ORDER—dated 20th December 1887, No. 3484 W., Public Works.

Madras Harbour

Despatch from the Secretary of State communicating, with remarks, report of the special committee on the question of the entrance to the —, communicated to the officers concerned.

In compliance with the instructions contained in your letter of 8th April, we have examined thoroughly into the subject of the position of the entrance to Madras Harbour, in connection with the work of reconstruction now in progress.

Drawing 1

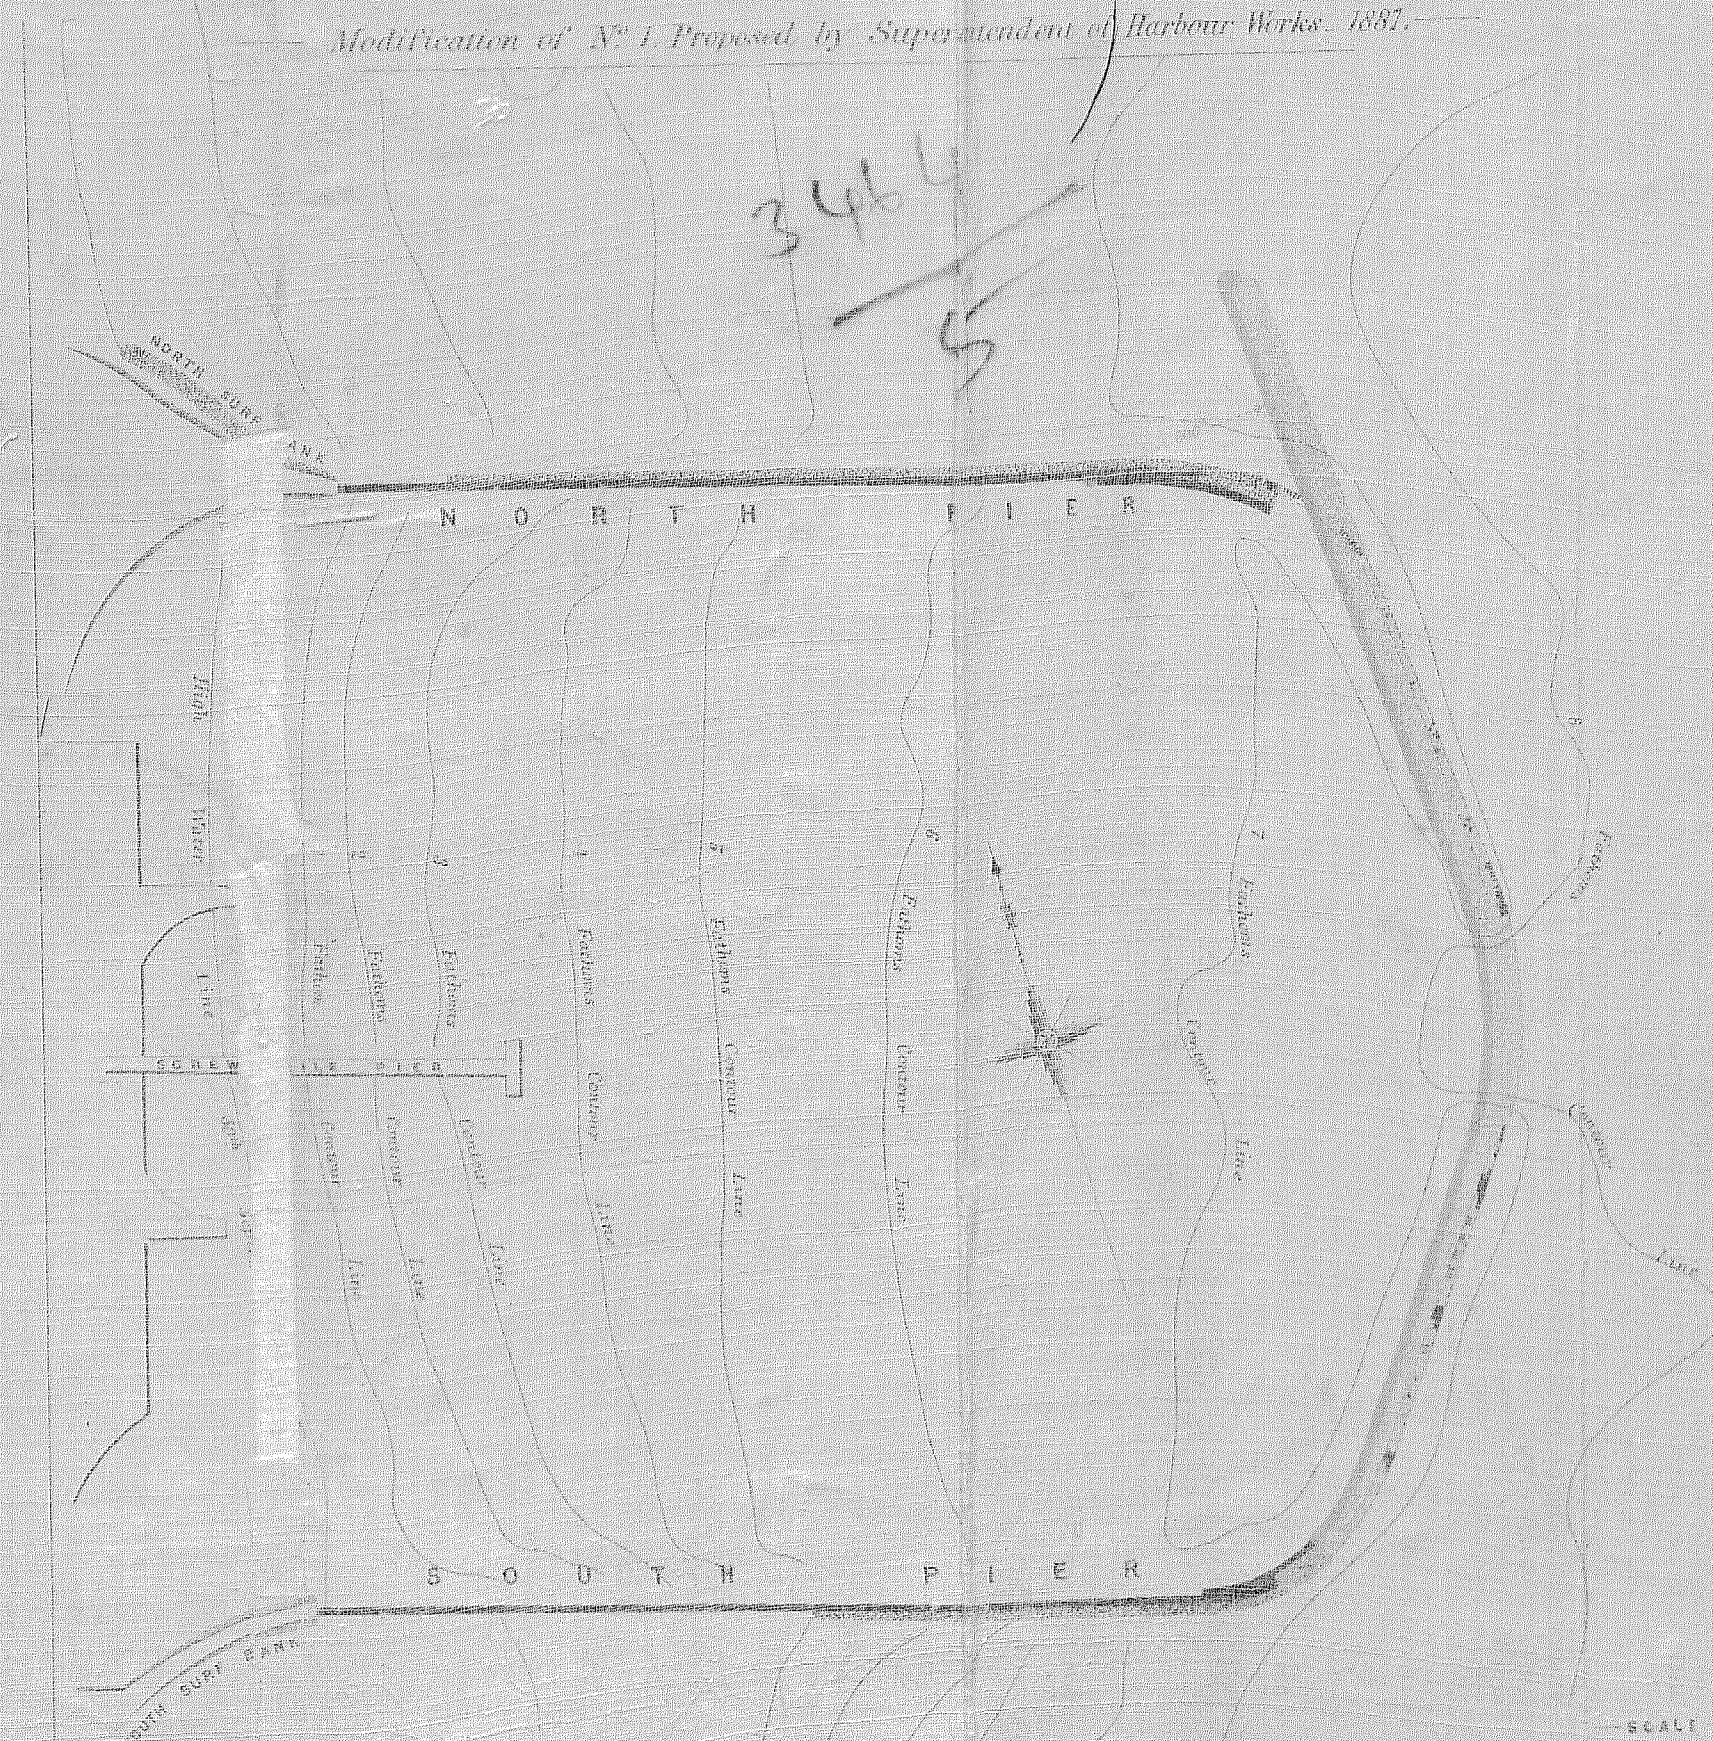
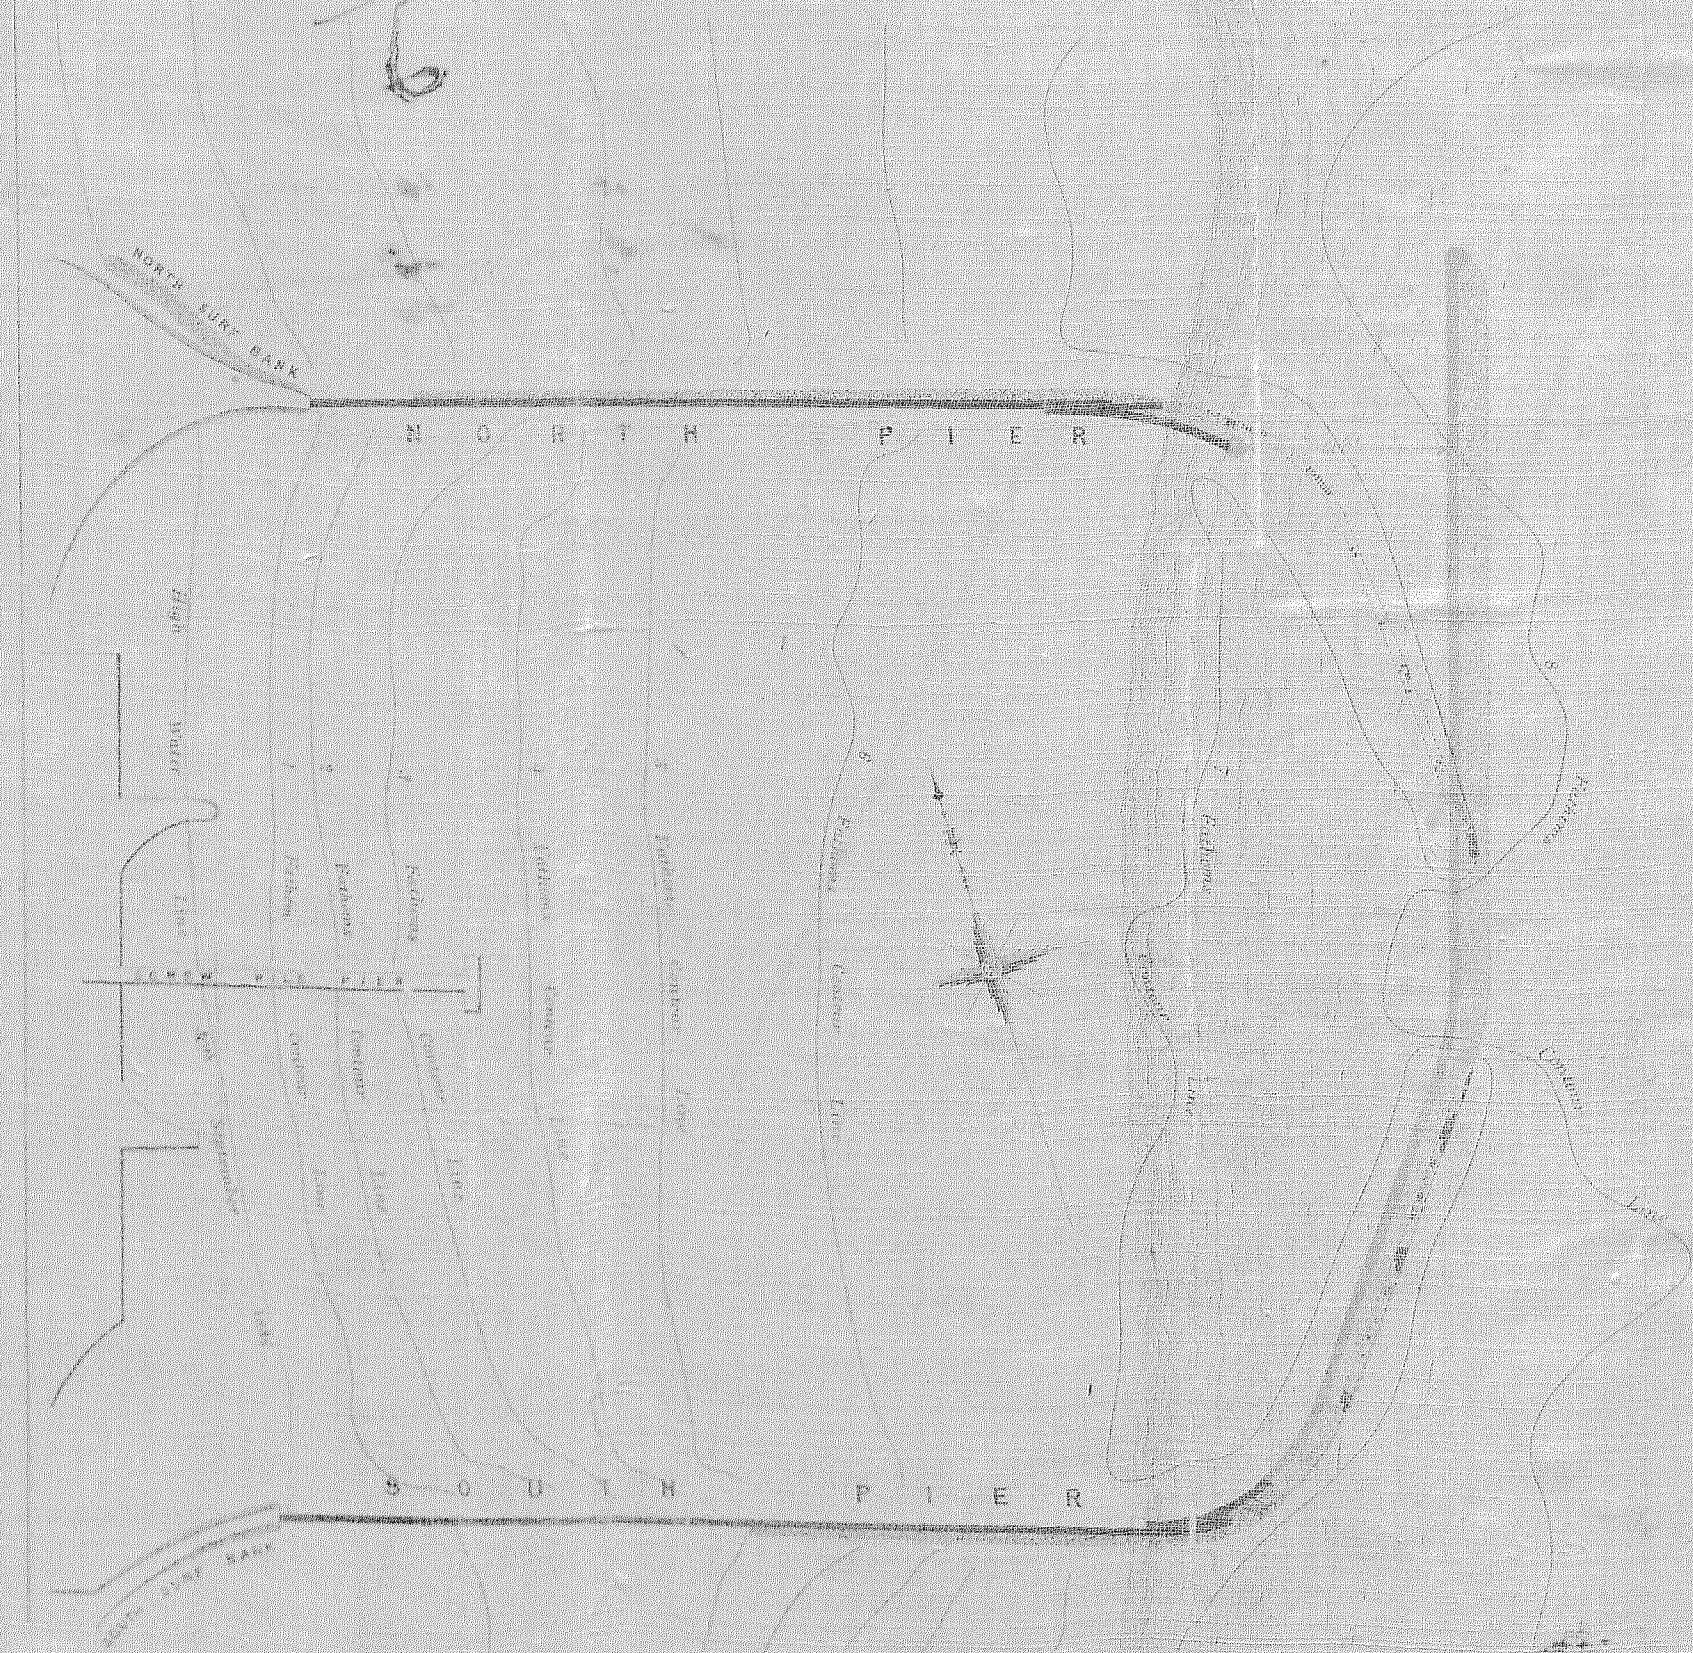
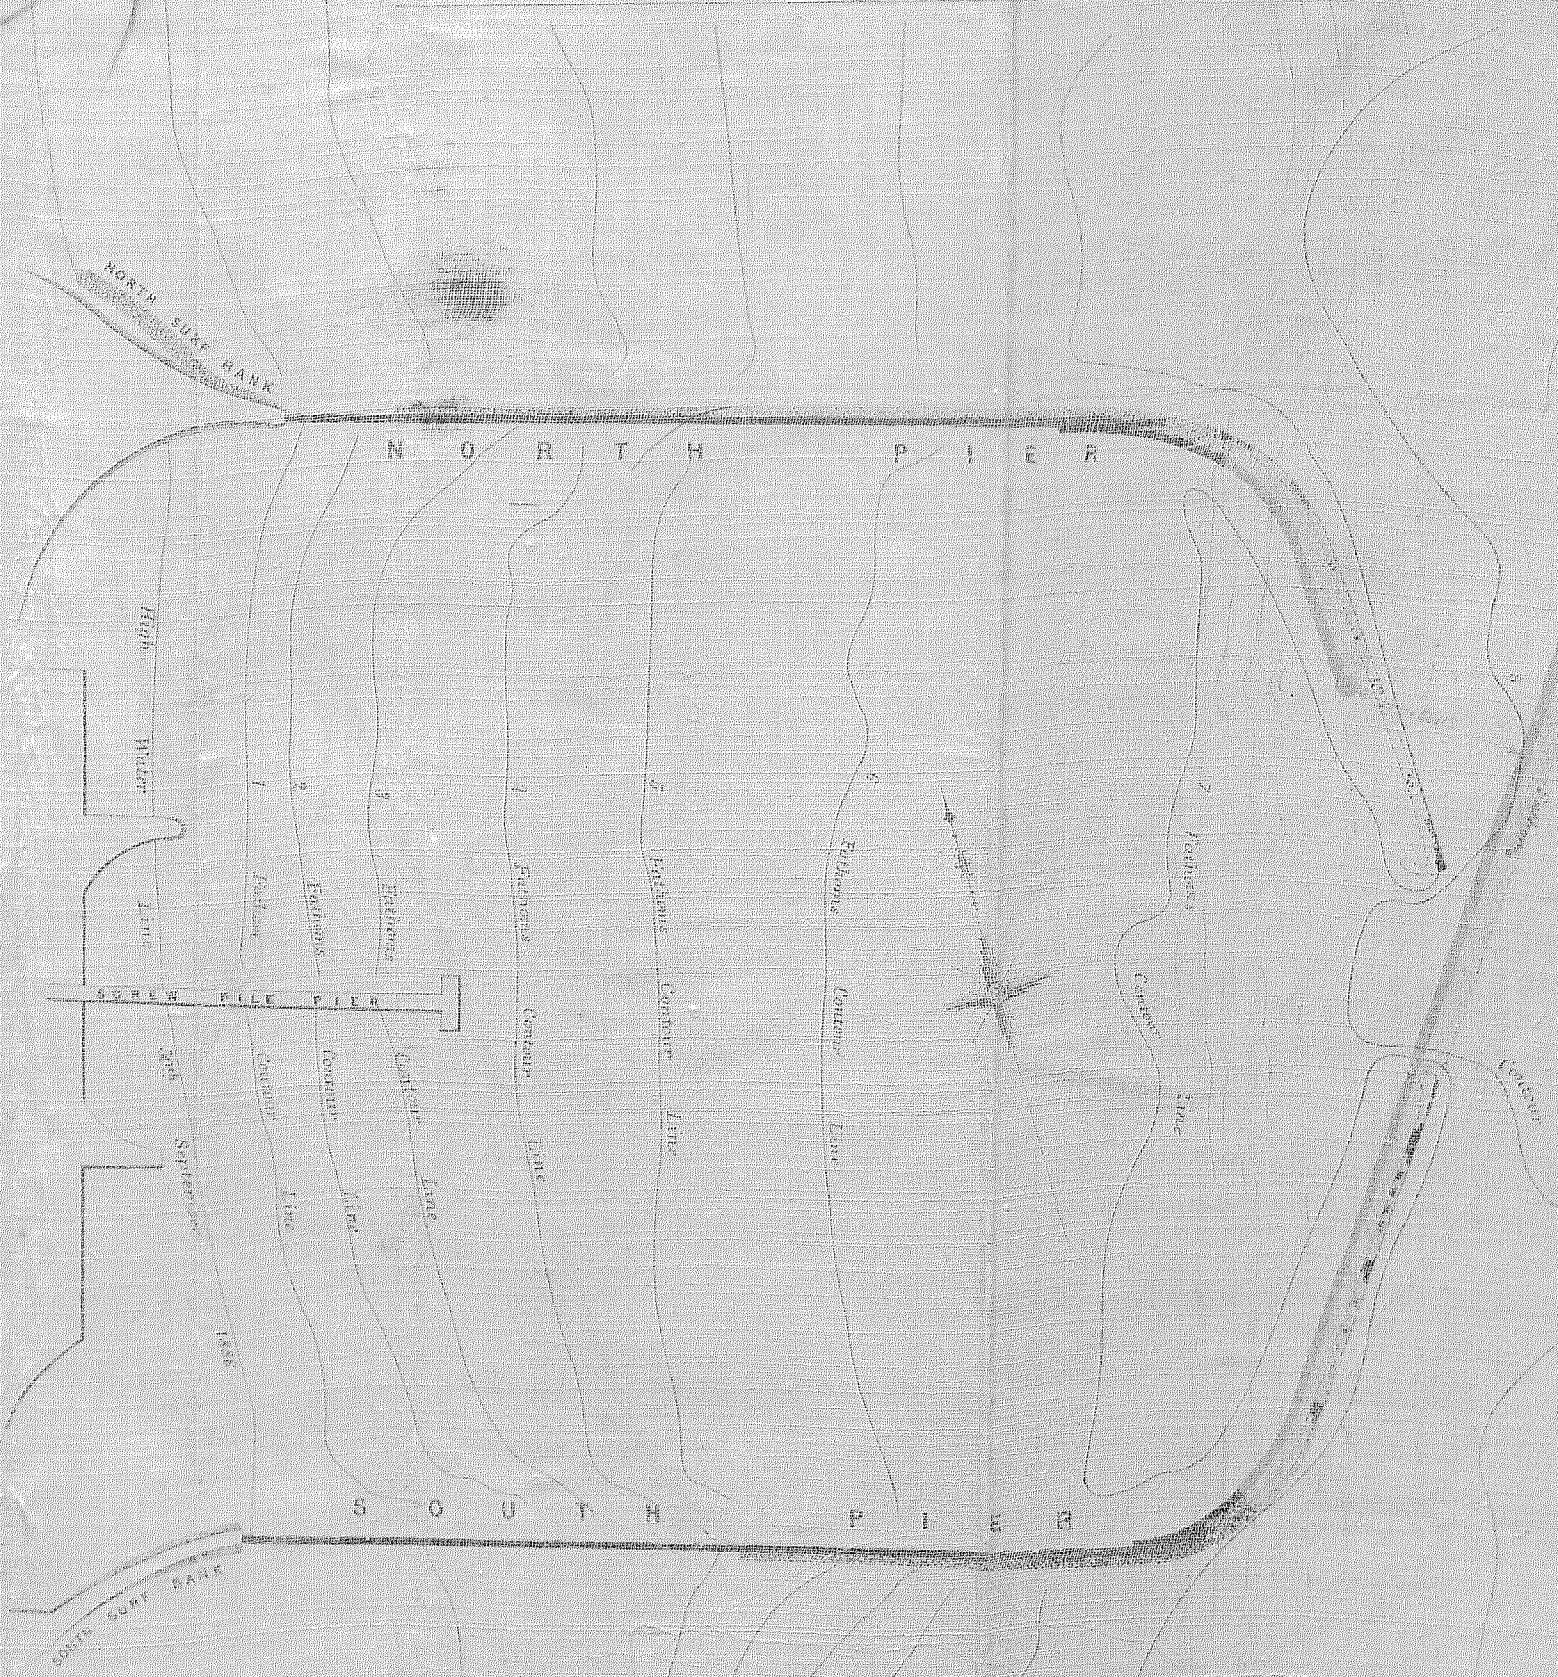
Drawing No. 1 exhibits the projects (numbered I., II., III., and IV.) described in a report on the different proposals for a north-east entrance, dated 2nd May 1887, and addressed to the Chairman of the Madras Harbour Trust Board by the Superintendent of the Harbour Works. These proposals were referred to by different witnesses in the evidence taken in the course of our inquiry.

Of the four plans submitted to us by the Madras Harbour Trust Board we give the preference on nautical grounds to Plan III., but with an addition to the length of the covering arm. What the precise length should be can be best determined by experience. We are of opinion, however, that the overlap should not be less than 600 feet, and need not be more than 800 feet.
